RE: Takapau WWTP Hydrogeology s92 Response (T:D.20)

As part of Central Hawke's Bay District Council (CHBDC) efforts to renew its consent for wastewater discharge at the Takapau Wastewater Treatment Plant (WWTP), a revised system comprised of spray irrigation of treated wastewater at the surface is proposed.

Figure 1: Shallow groundwater elevations (mRL) at Takapau WWTP site, 8 June 2021. Red arrow shows interpreted groundwater flow direction.

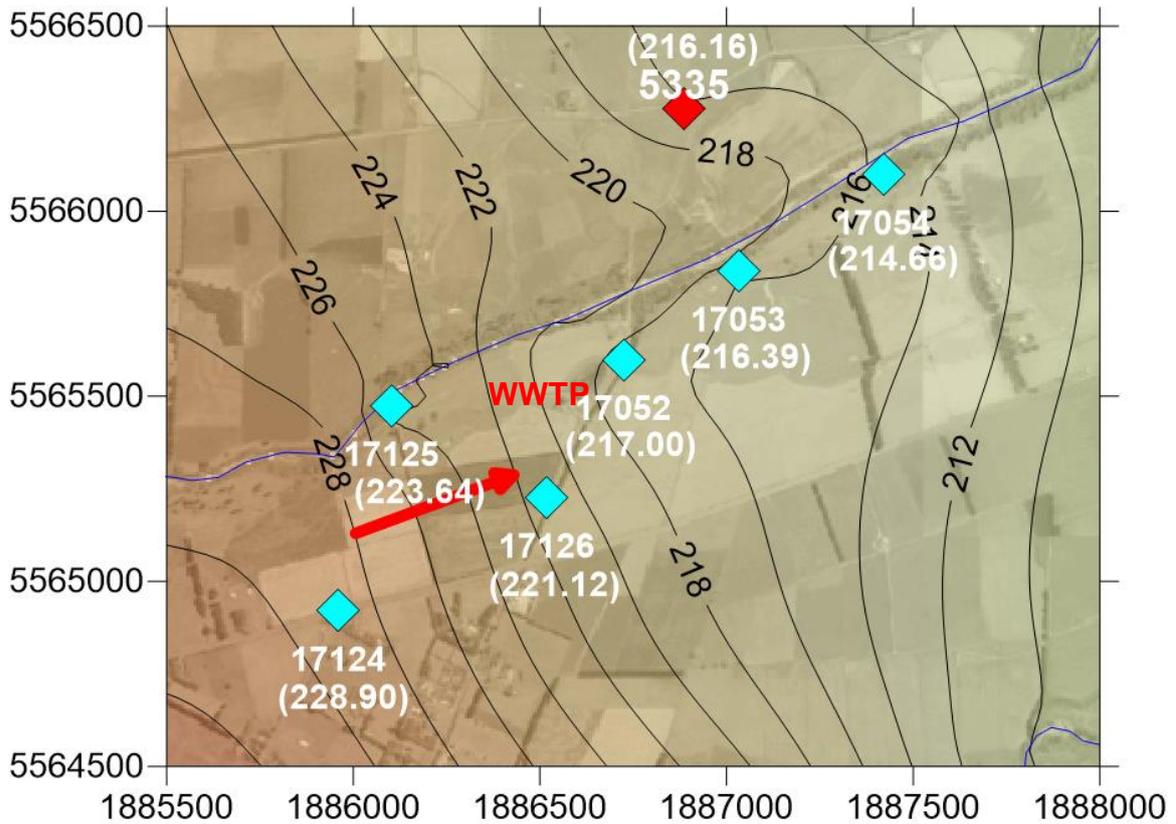
Comment No. 20 in the 27 May 2021 Request for Further Information relates to the potential impact from groundwater at the Takapau WWTP on the Pōrangahau Stream:

“The groundwater review indicates that groundwater beneath the proposed irrigation area is likely to travel in an east-southeast direction and resurface within the gaining reaches of the Pōrangahau Stream.”

Beca’s groundwater review does not conclude that groundwater beneath the Takapau WWTP flows to the ESE. Based on the water level measurements in the six new piezometers installed at and around the proposed irrigation area, the shallow groundwater is interpreted to flow toward the ENE, sub-parallel to the Makaretu River.

As shown on Figure 1, water levels were recently measured in the six piezometers on 8 June 2021 and confirm that the shallow groundwater flow direction at the Takapau WWTP is interpreted to be to the ENE, consistent with the previous measurements in February 2021.

We believe that the misunderstanding of the conclusions of our review (that shallow groundwater flow at the Takapau WWTP was to the ESE) may have been due to the groundwater flow vectors shown on Figure 8 of our report³, of which one vector indicated an ESE direction as a result of a localised “bulls-eye” around one monitoring point, but more generally the flow is to the E and ENE consistent with Figure 1 above.

While there may be some uncertainty whether the shallow groundwater flow direction is interpreted to be toward the ENE or to the east, there is little chance that shallow groundwater from the Takapau WWTP site would flow upgradient towards the south or southwest. As shown in Figure 1, there is a strong hydraulic gradient in the shallow groundwater at the Takapau WWTP toward the ENE with the water level in the upgradient piezometer (17124) being more than 6 m higher than the nearest downgradient piezometer (17126) located about 600 m away.

Figure 2: Conceptual 3D model showing the regional shallow water elevation in the area around Takapau WWTP. Abstracted from Figure 7 of Beca (2021).

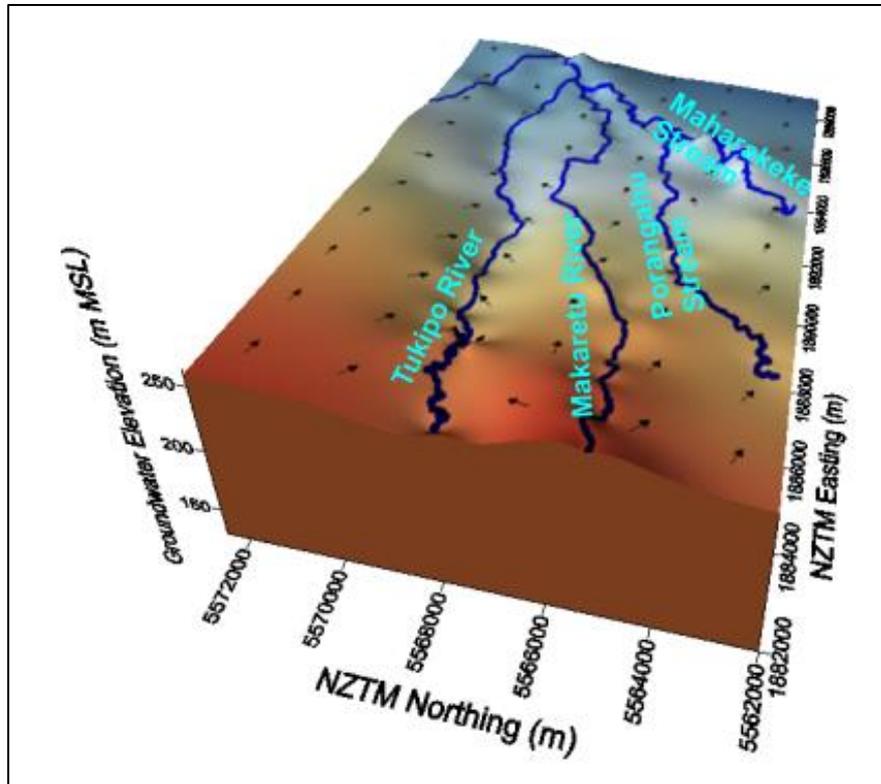
PDP states that our study corroborates the findings of Johnson (2011)⁴ that the Pōrangahau Stream **gains flow** from groundwater as it flows to the east. In their review, PDP also mentioned that they expect that the Pōrangahau Stream is the most likely receiving environment of the treated wastewater discharge from the Takapau WWTP (towards the gaining Pōrangahau Stream and away from the losing reach of the Makaretu River).

In the Beca groundwater review⁵, we did not make any statement about the Pōrangahau Stream since our main concern was with the Makaretu River. In our assessment, we agreed with Johnson (2011) about the Makaretu River losing water to groundwater near the Takapau WWTP area (Figure 1). This is consistent with the regional map in Johnson (2011), presented as Figure 5 in our report, which shows the Makaretu River as a losing reach in the vicinity of the Takapau WWTP. This same map shows the Pōrangahau Stream as a gaining reach east of the Takapau WWTP.

However, the lack of groundwater level data points near the Pōrangahau Stream constrained our capacity to provide any statements beyond the general regional scale for that stream. If any assessment for the Pōrangahau Stream on a local scale is to be done based on our conceptual groundwater model, the most reasonable one is that the Pōrangahau Stream is actually conservative or slightly losing water to groundwater upstream from the confluence with the Maharakeke Stream, and losing downstream from that point. This is illustrated in the 3D hydrogeological model presented in Figure 7 of our report (Figure 2 below).
